Lancaster Twp. Br. #15
Hwy. 401 at R.A. between
Lots 1 & 2, Conc. 1,
Lancaster Twp., Dist. 9

FOUNDATION INVESTIGATION REPORT

Re: Proposed Crossing, Highway 401 and
Road Allowance Between Lots 1 and 2,
Concession 1, Township of Lancaster,
District No. 9 -- W.P. 175-60.

PROPOSED CROSSING
HIGHWAY 401 AND ROAD ALLOWANCE
BETWEEN LOTS 1 AND 2, CONCESSION 1,
TOWNSHIP OF LANCASTER, DISTRICT NO. 9
WP 175-60

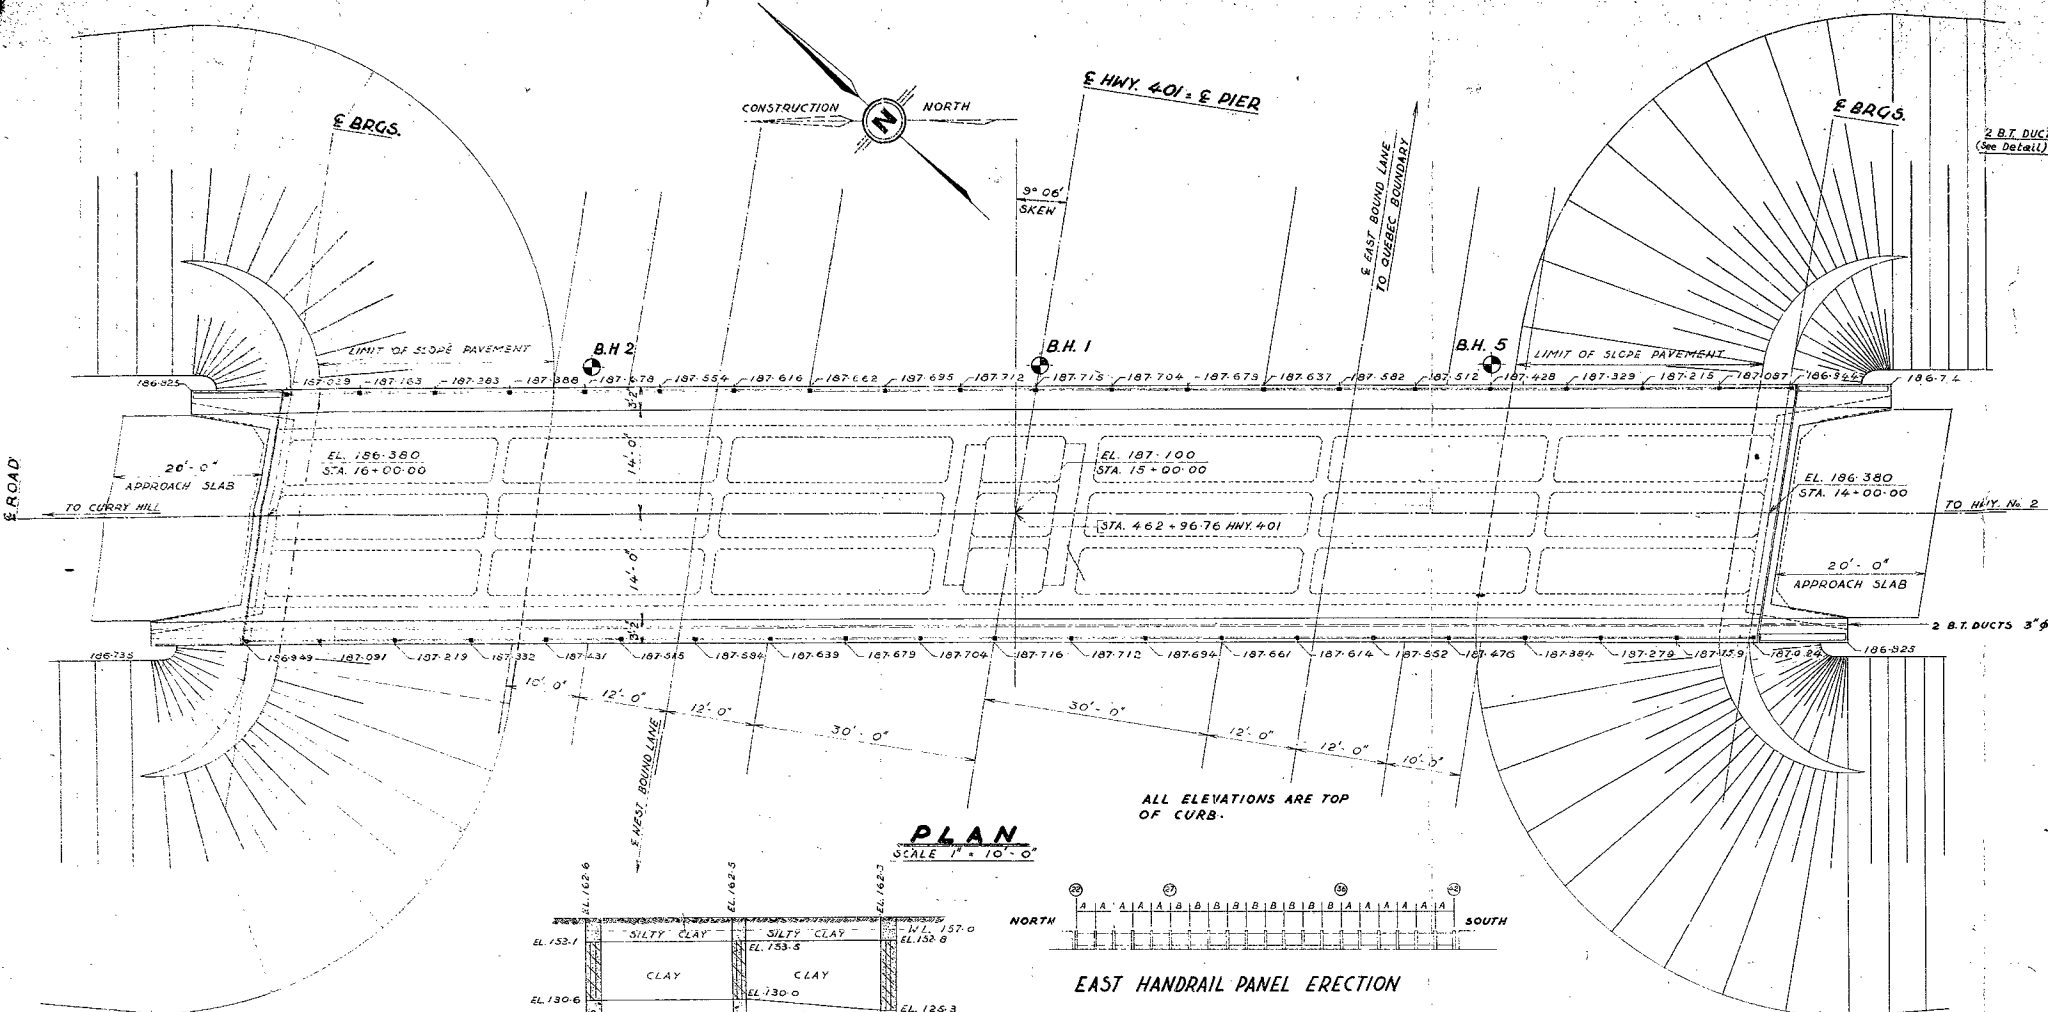
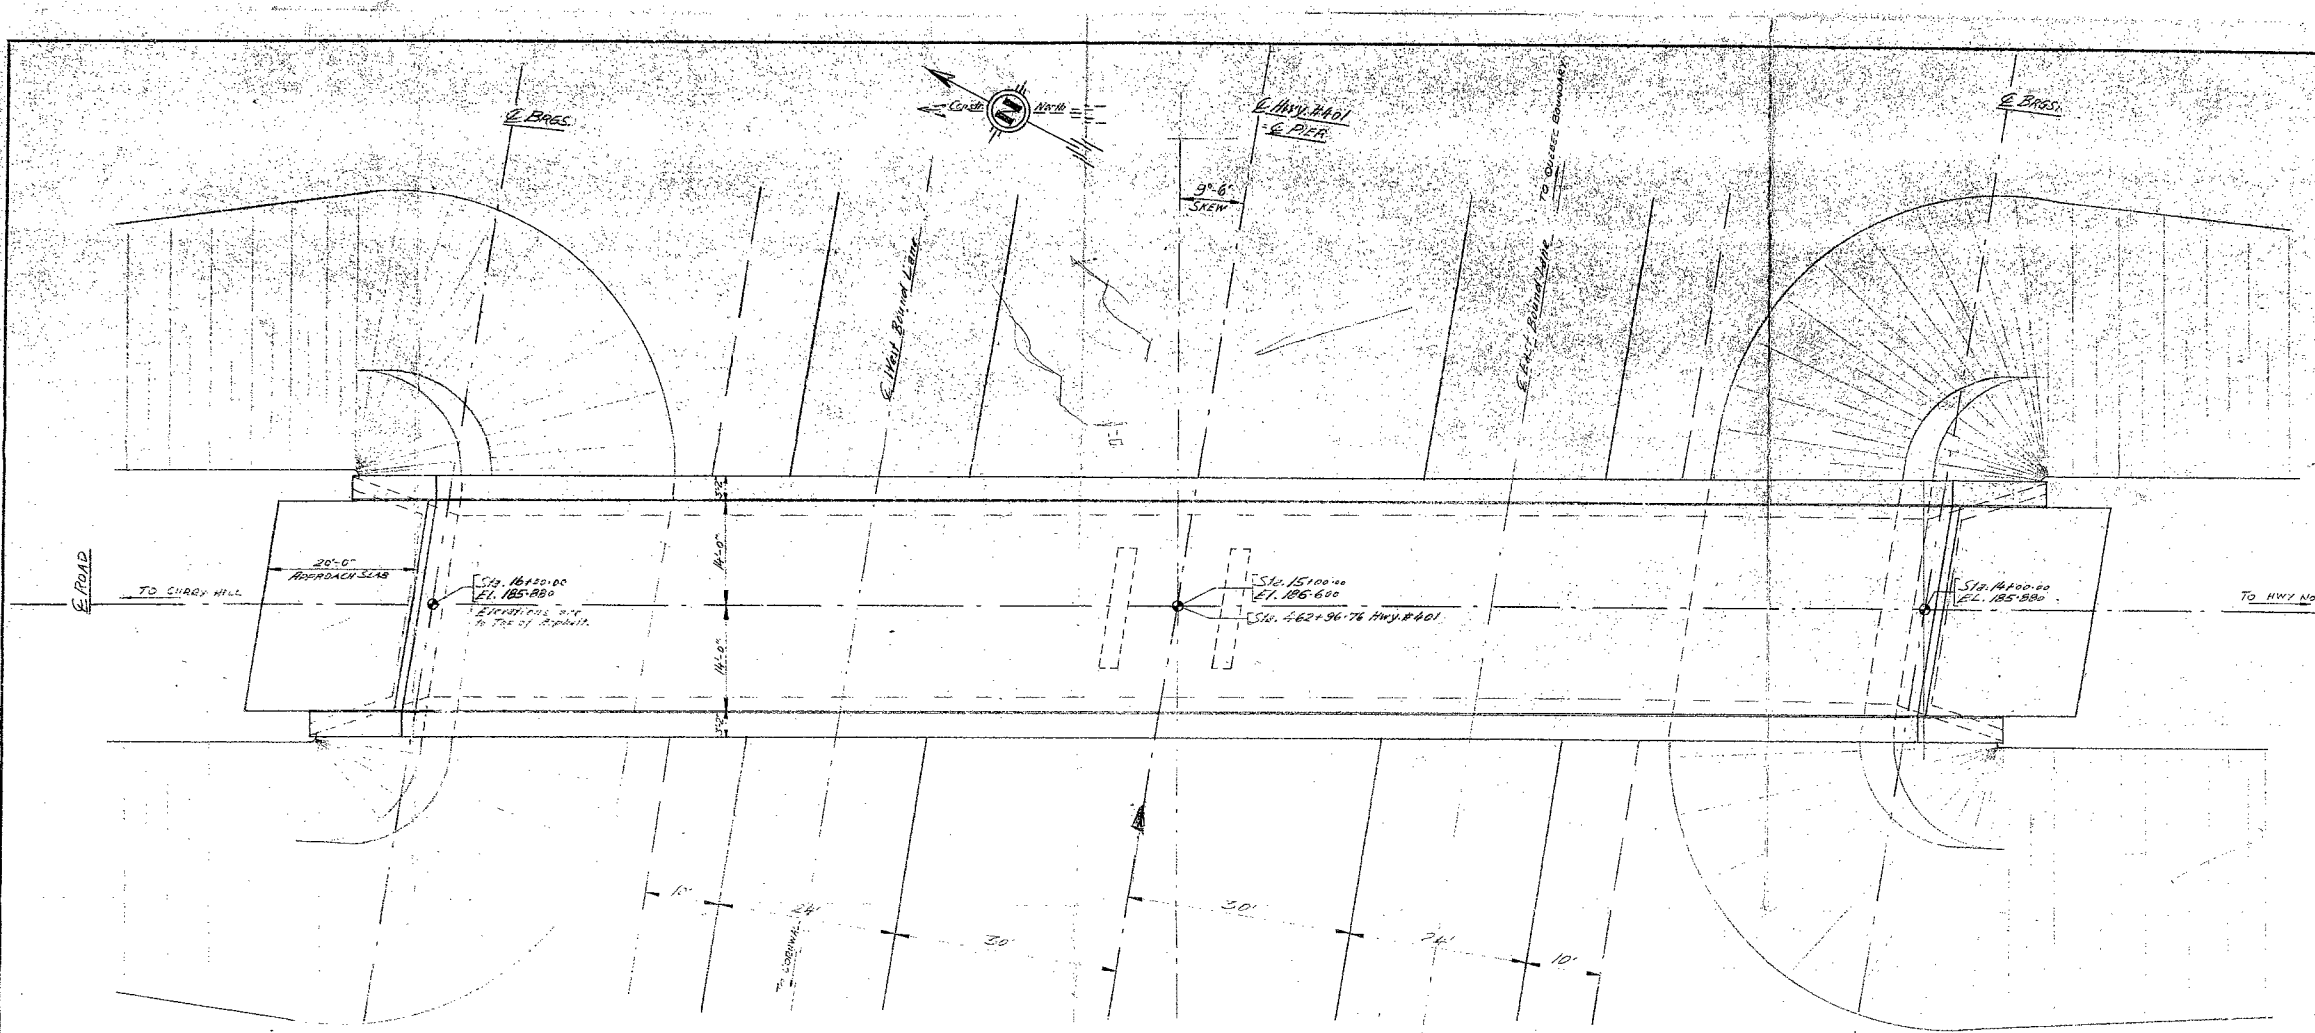
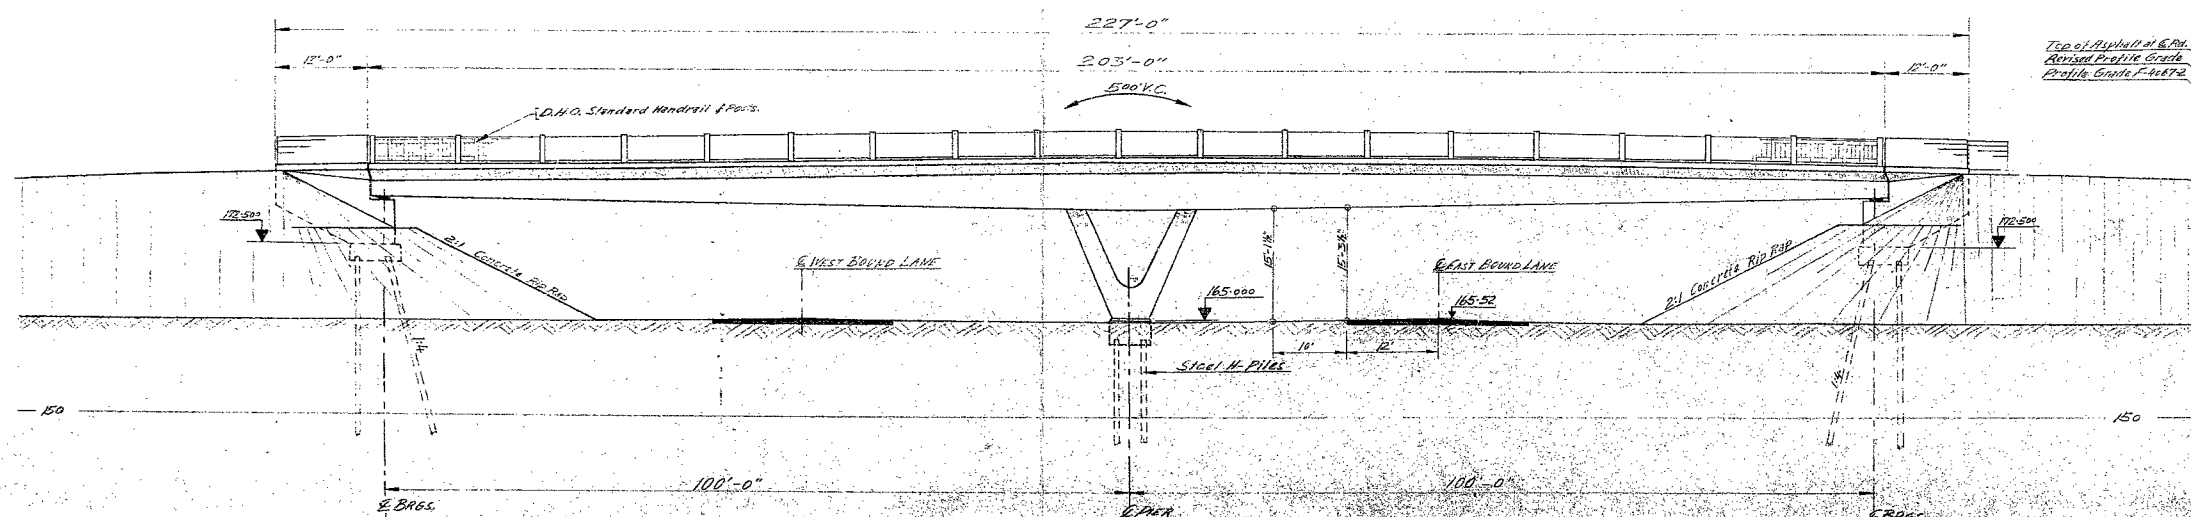
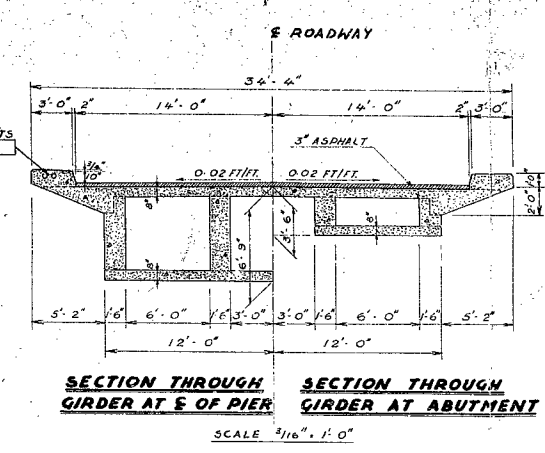
With reference to your letter of December 8, 1960,
we have received the preliminary plan of the above mentioned
structure and have no comments.

The designer appears to have complied with the
requirements of the foundation report but we would
appreciate any comments you wish to make.
